PUBLIC HEARING MEMORANDUM

SUBJECT: **Petition #360-21** to construct an addition to the existing structure and a second two-unit structure, allowing four single-family attached dwelling units in two buildings, to allow reduced side and rear setbacks and to allow a driveway within ten feet of the side lot line, **50 Highland Avenue**, Ward 2, on land known as Section 24 Block 11 Lot 34, containing approximately 22,738 sq. ft. of land in a district zoned MULTI RESIDENCE 1. Ref: Sec. 7.3.3, 7.4, 3.4.1, 3.2.4, 6.2.3.B.2 of Chapter 30 of the City of Newton Rev Zoning Ord, 2017.

50 Highland Avenue

ZONING REVIEW MEMORANDUM

Proposed site plan (Highland Avenue frontage to left)

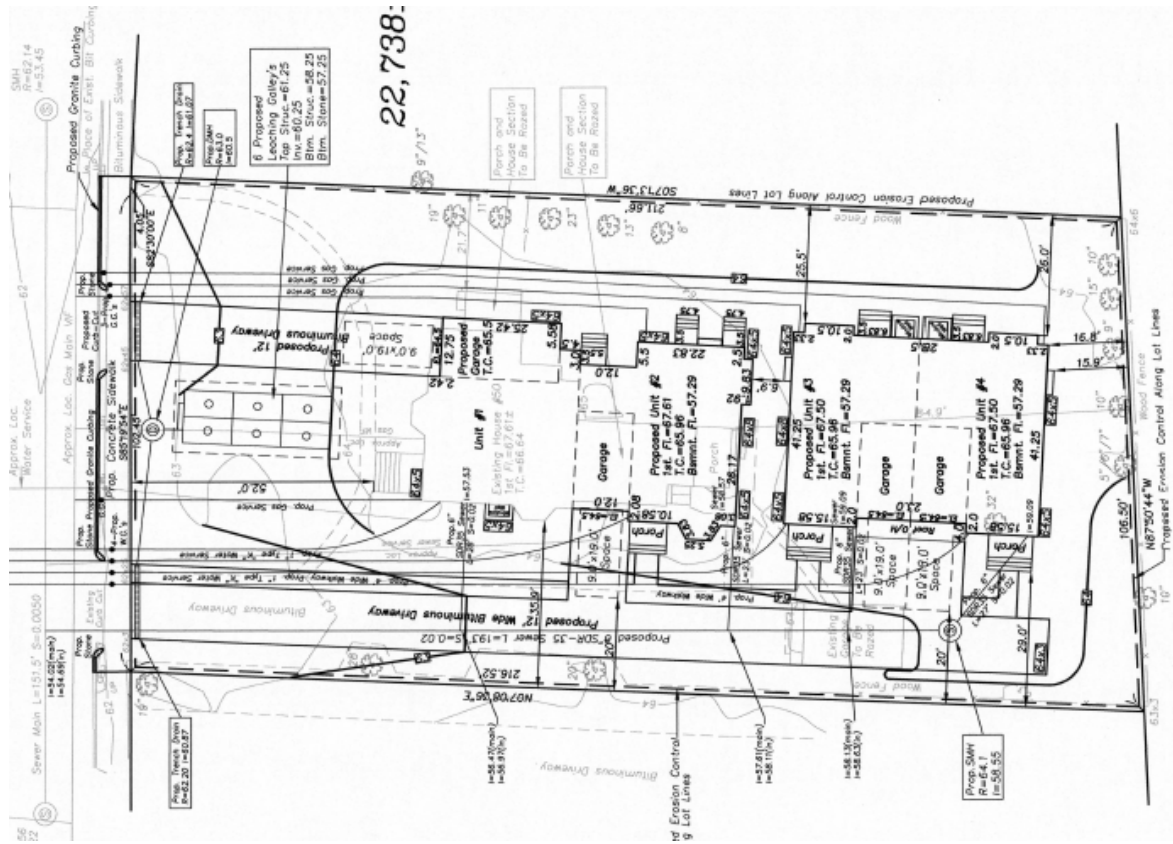
As to the proposed rear Building 2, the rear setback would be 16.8 feet, approx. seven feet less than the required 25 feet. Its right (west) side setback of 29 feet would be conforming. Regarding its left (east) setback, the attached Zoning Review memo indicated that it would measure a nonconforming 22.5 feet, and the petitioner has requested relief to allow a side

setback of that depth. However, the Planning Department notes that the petitioner-submitted site plan appears to indicate a minimum setback on that side of 25.5 feet, more than the required 25 feet. The petitioner should confirm that measurement to determine to location and depth of the narrowest left (east) side setback for both of the structures.

The Planning Department notes that the proposed removal of portions of the rear of the existing dwelling and the existing detached garage would result in a largely vacant rear half of the lot with few if any physical constraints and, therefore, the nonconformities requiring relief, such as the deficient rear setback, would seem to be the results of design and program choices. Indeed, much of the rear setback deficiency is a product of separating the proposed development into two structures, with the separation imposing the reduced rear setback on adjacent properties.

As such, it is likely that the petitioner could construct the proposed four units without any new construction encroaching into the required 25-foot setbacks. The Planning Department recommends that the petitioner consider reconfiguring the proposed structure(s) and site design to minimize the relief required.
